Project	IEEE 802.16 Broadband Wireless Access Working Group < http://ieee802.org/16 >	
Title	Corrections on Unsolicited RNG-RSP in Non-transparent RS System under Centralized Scheduling	
Date Submitted	2007-07-18	
Source(s)	Kanchei (Ken) Loa, Yi-Hsueh Tsai, Yung-Ting Lee, Hua-Chiang Yin, Shiann-Tsong Sheu, Youn-Tai Lee,	Voice: +886-2-27399616 Fax: +886-2-23782328 loa@iii.org.tw
	Institute for Information Industry 8F, No. 218, Sec. 2, Dunhua S. Rd., Taipei City 106, Taiwan	
Re:	IEEE 802.16j-07/019: "Call for Technical Comments Regarding IEEE Project 802.16j"	
Abstract	This contribution proposes the modified figures of MS unsolicited RNG-RSP in non-transparent RS system under centralized scheduling scheme based on comment #1141 of 80216j-07_014r4.cmt.	
Purpose	Text proposal for 802.16j Baseline Document.	
Notice	<i>This document does not represent the agreed views of the IEEE 802.16 Working Group or any of its subgroups. It represents only the views of the participants listed in the "Source(s)" field above. It is offered as a basis for discussion. It is not binding on the contributor(s), who reserve(s) the right to add, amend or withdraw material contained herein.</i>

Correction on

Table 201x—Unsolicited RNG-RSP triggered by uplink traffic in non-transparent mode

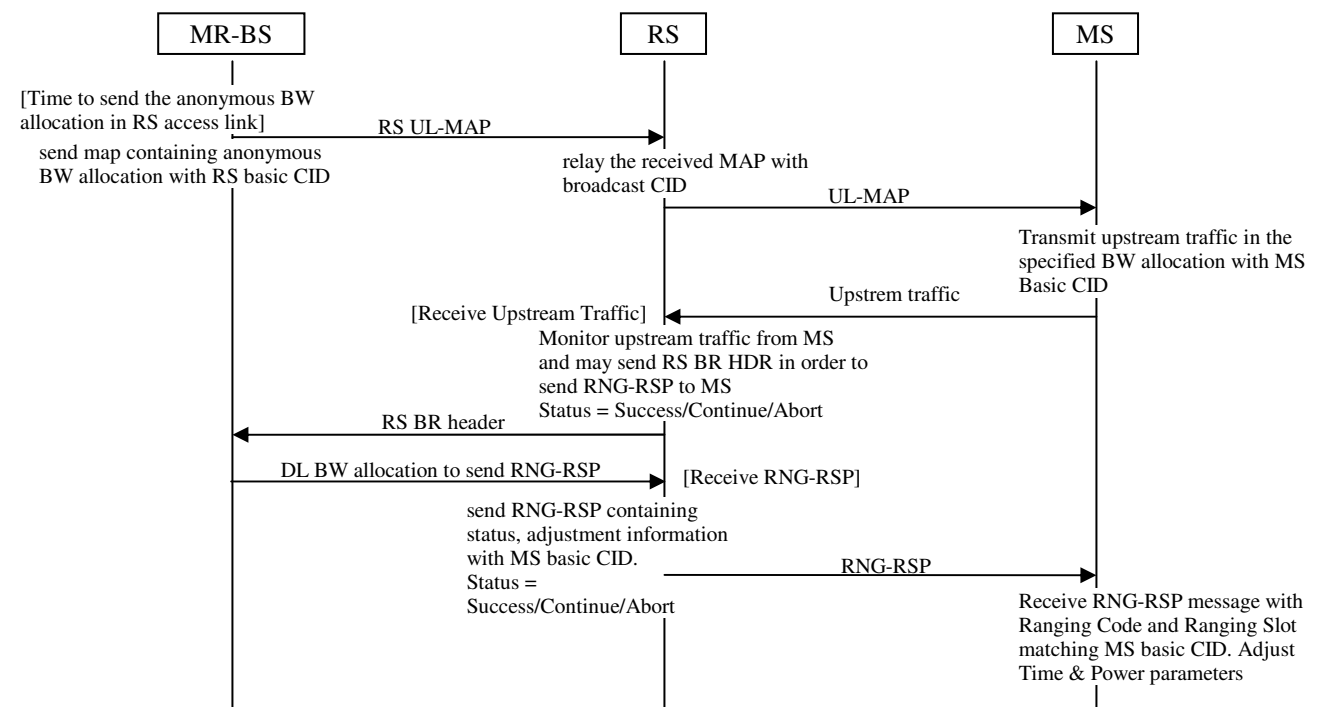
[Inserted the following Table in page 101 as indicated]

Figure 108x—Unsolicited RNG-RSP triggered by upstream traffic at Access non-transparent RS

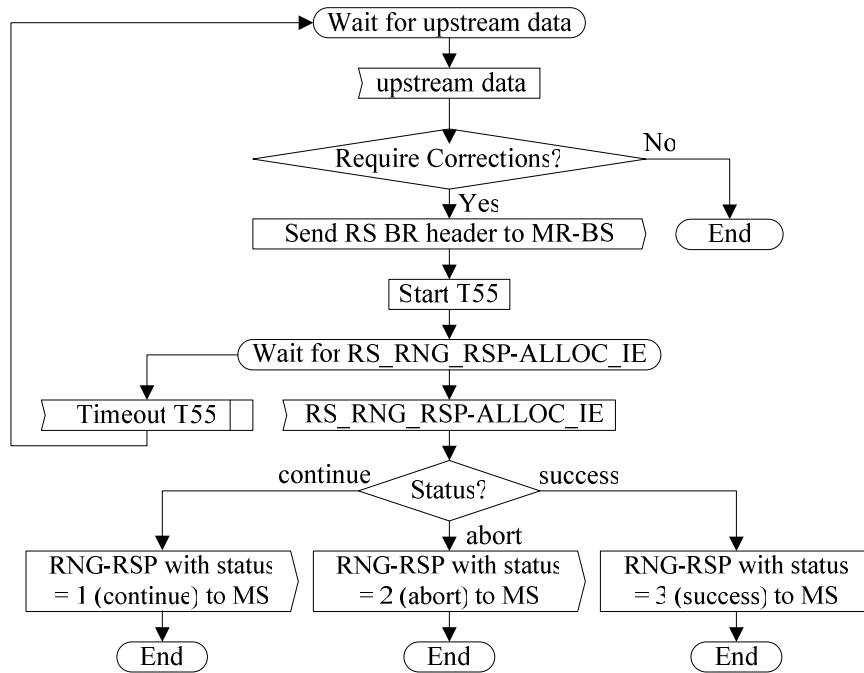
[Inserted the following figure in page 101 as indicated]

Figure 108j—Unsolicited RNG-RSP triggered by BR ranging code at Access non-transparent RS

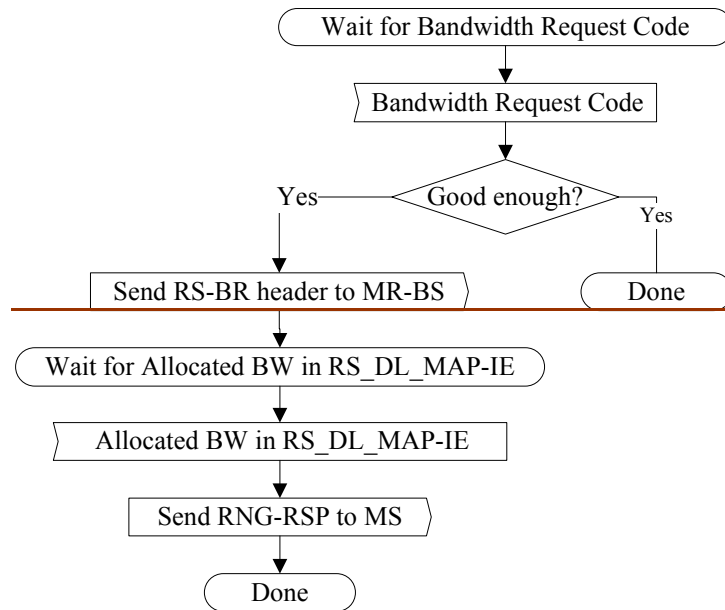
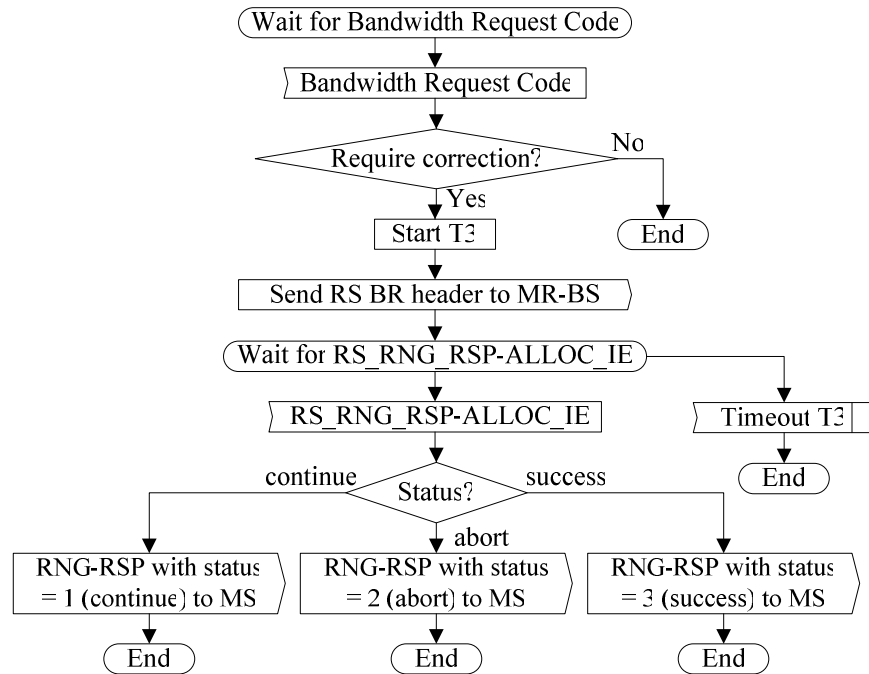
[Replaced the following figure in page 101 as indicated]

Figure 108k—Unsolicited RNG-RSP triggered by BR ranging code in non-transparent RS system—MR-BS

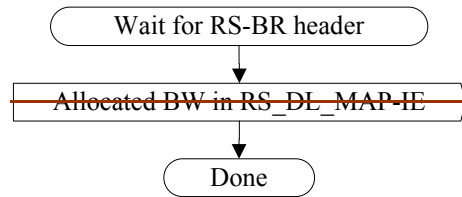
[Deleted the following figure in page 101 as indicated]
